AGENDA
TECHNICAL REVIEW COMMITTEE
AUGUST 7, 2018
10:00AM

WESTMINSTER PINE RIDGE ROADWAY & UTILITY DEVELOPMENT CONSTRUCTION PLANS CITY OF FRUITLAND PARK, FLORIDA

**CITY OF FRUITLAND PARK
STAFF REPORT BY LPG URBAN & REGIONAL PLANNERS, INC.**

NOTE:
CONTRACTOR TO PROVIDE A MINIMUM OF 3 FEET OF COVER OVER PROPOSED 6" F.M.

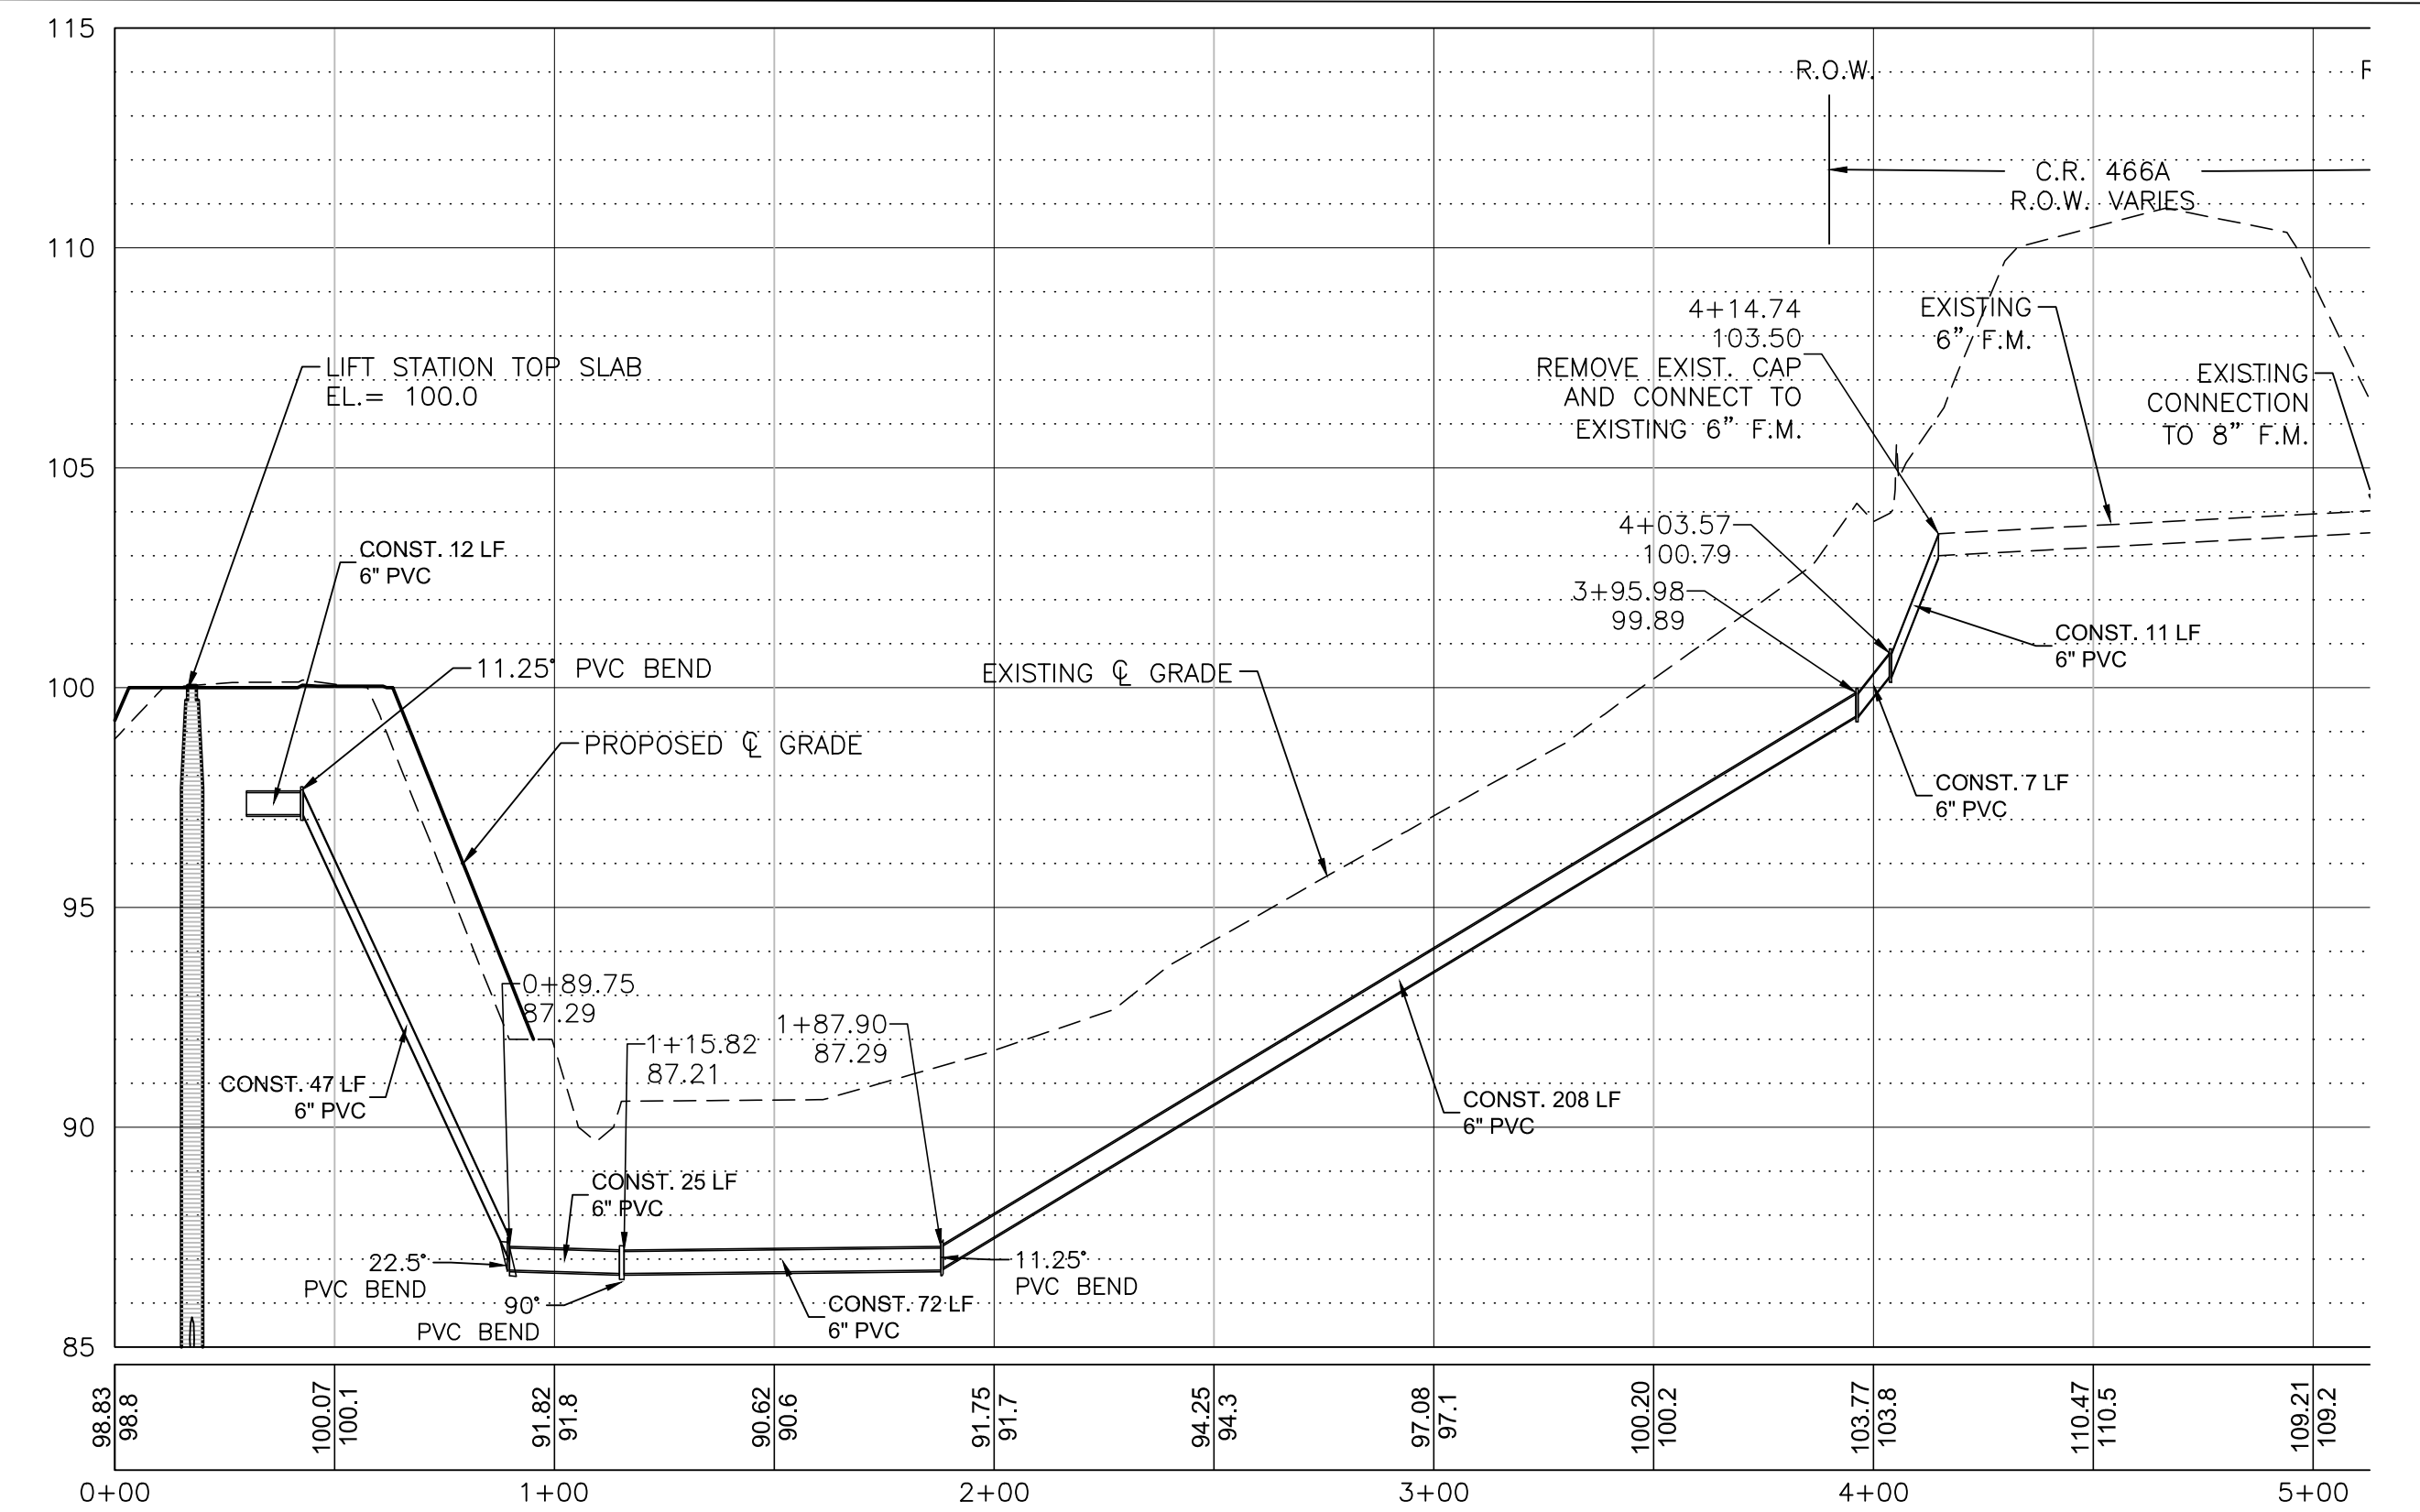
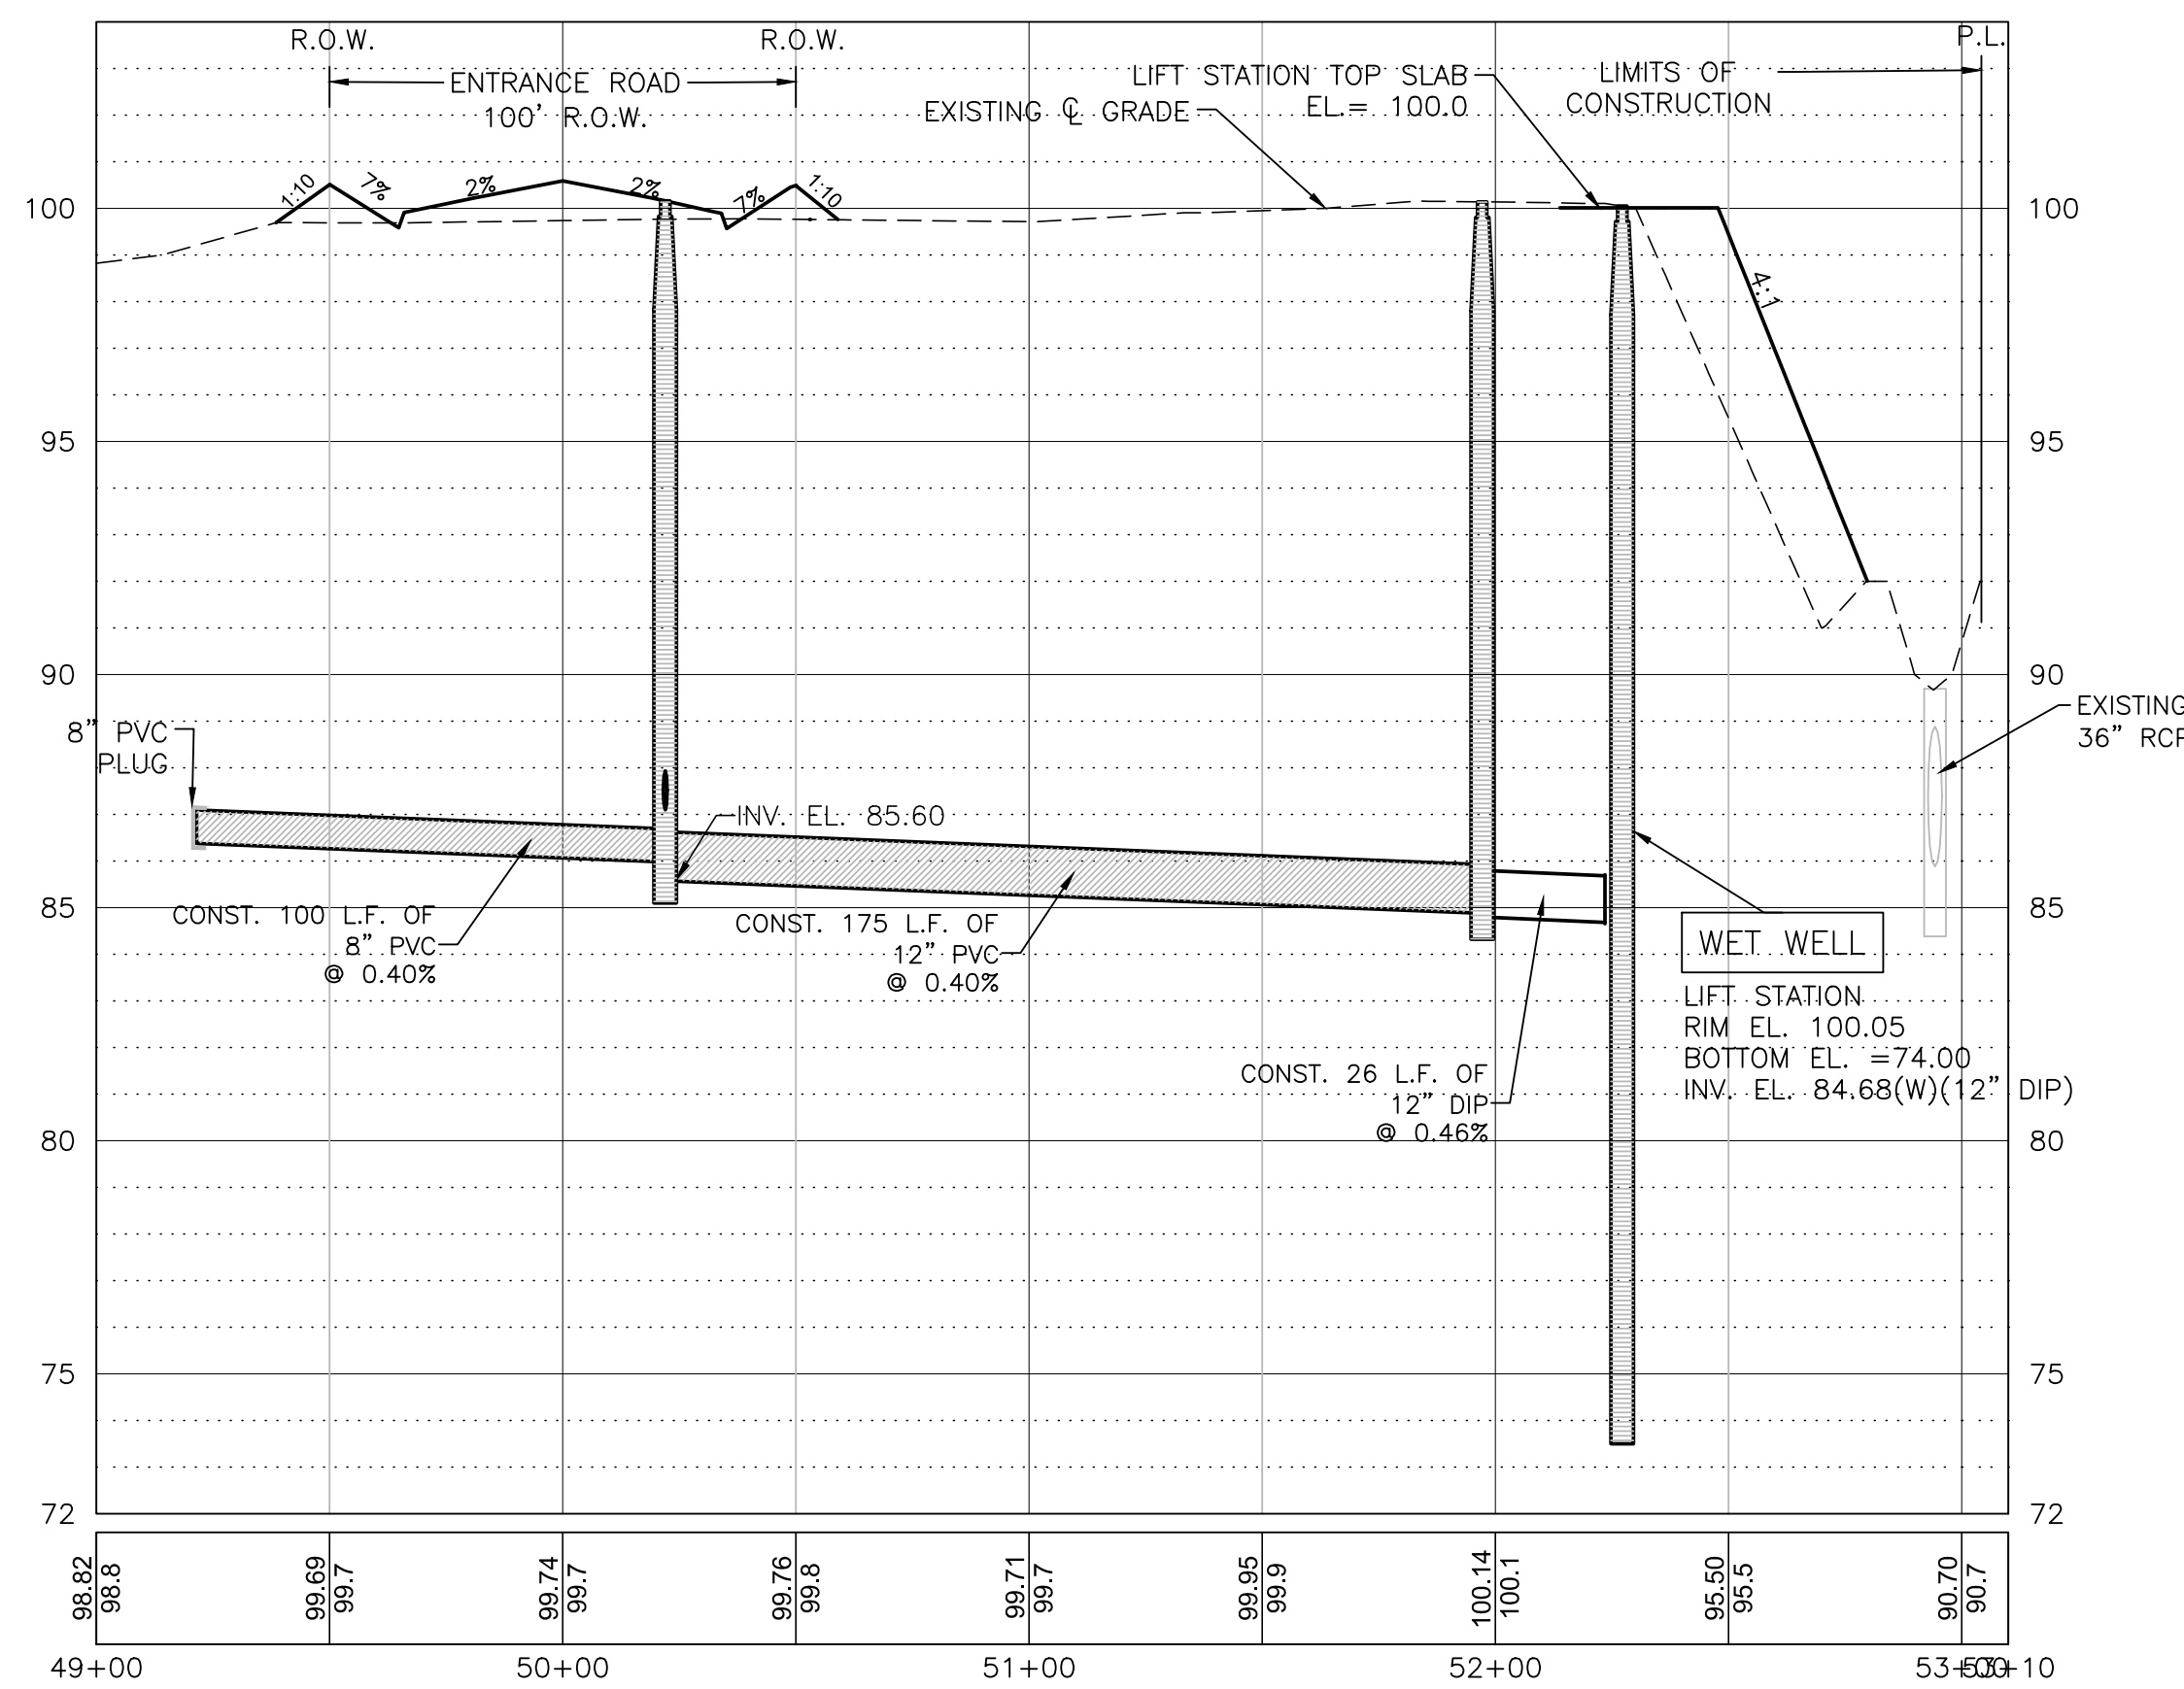
11. Sheet C-11 – Install a plug valve on the proposed force main at the right-of-way line.
